OLSOM'S FOODS TEST KITCHEN
EDMONDS, WASHINGTON

FLOOR/EQUIPMENT PLAN, DETAILS, ELEVATION AND NOTES

Plan Check: 3178
Project: Restaurant Remodel for
Olsons Test Kitchen
Address: 22828 100th Ave W
Code Information: A3 Occupancy;
Type V-Nonstructural
1988 Uniform Mechanical Code

Re: Olson's Food Test Kitchen Plan Check #3178

A/1 ELEVATION
SCALE: 1/4" = 1'-0"

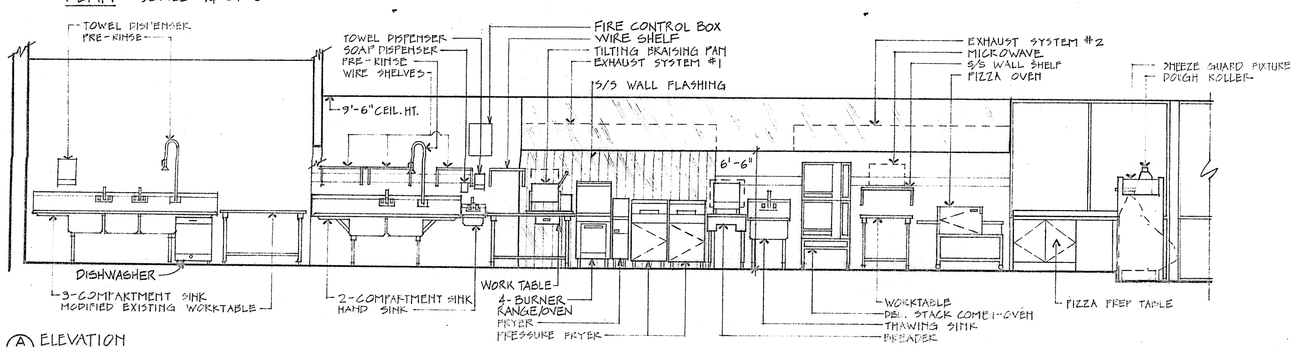
1. There are two interior elevations 1/1 only one of which is shown. The second one should show the dishwasher which requires a type 2 hood over it, Section 2003(a). The wash sinks may also require a hood if large amounts of steam are generated.

1. Elevation 1/1 is shown long enough and does include the dishwasher area. This dishwasher is a Hobart under counter unit and does not require a type 2 hood. It is a small unit, we have verified this with the Hobart representative. Large amounts of steam will not be generated from the wash sinks, thus a type 2 hood will not be required.

SHAFT DETAIL
SCALE 1" = 1'-0"

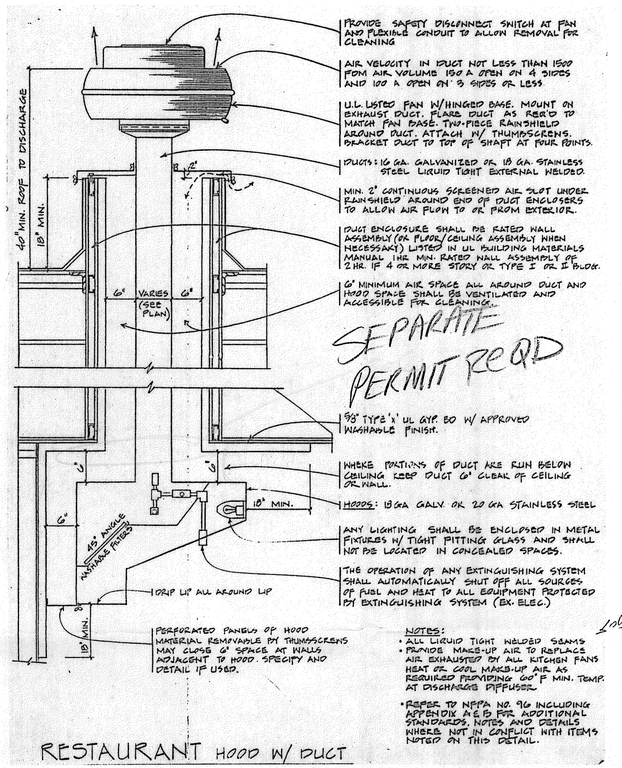
3. The shaft shown on sheet 2 should be referenced to a listed assembly so that we can ensure that the framing shown actually complies as a one hour enclosure, Section 2002(d) UMC and Section 4302(a) UBC.

3. The duct shaft shown is to be of 1 hour construction. It is made up of 2 x 4 metal studs with 5/8" type 'X' gyp board both sides.
